DART SERVICE INSTRUCTION

TO AMEND INSTALLATION INSTRUCTIONS D350-607-3 Rev.D,
INSTALLATION INSTRUCTIONS D350-607-4 Rev. C AND
INSTRUCTIONS FOR CONTINUED AIRWORTHINESS ICA-D350-607 Rev. 6

DRAWING NO. DSI 9699

LUG REPLACEMENT

FIGURE 1: INSTALLATION OF D4775-041 FWD STRUT

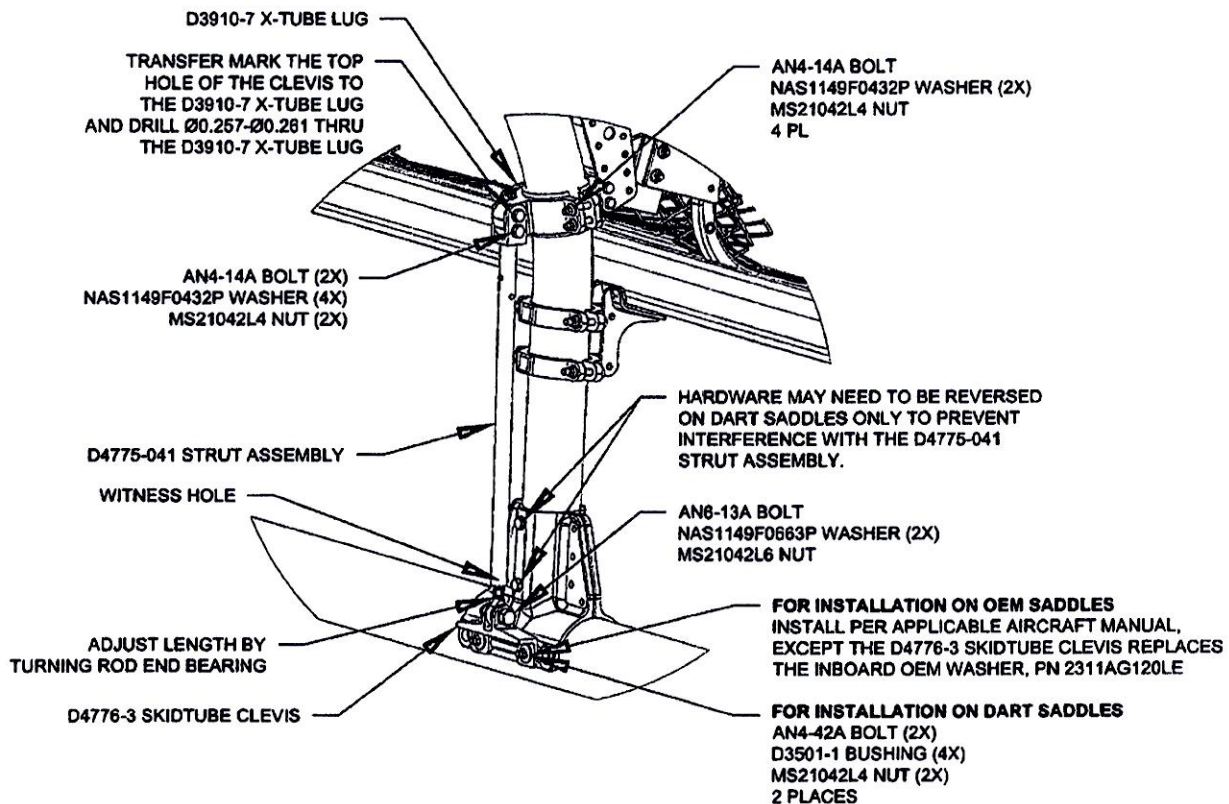
3.1 Substitute the Forward Lower D3910-5 X-Tube Lug with the D3910-7 X-Tube Lug as shown in Figure 1.

3.2 Install the forward D4775-041 Strut Assembly. Transfer mark from the upper hole on the clevis of the D4775-041 Strut Assembly to the D3910-7 X-tube Lug and drill thru the lug $\varnothing 0.257$ - $\varnothing 0.261$ as shown in Figure 1. Touch up chemical conversion coating per MIL-DTL-5541. Check the witness holes located at the bottom end of the D4775-041 Strut Assemblies to ensure that the thread from the rod end extends past the witness hole.
Torque MS21042L4/-4 nuts to 50-70 in-lbs (5.7-7.9 N-m). Torque MS21042L6/-6 nuts to 160-190 in-lbs (18.1-21.5 N-m).
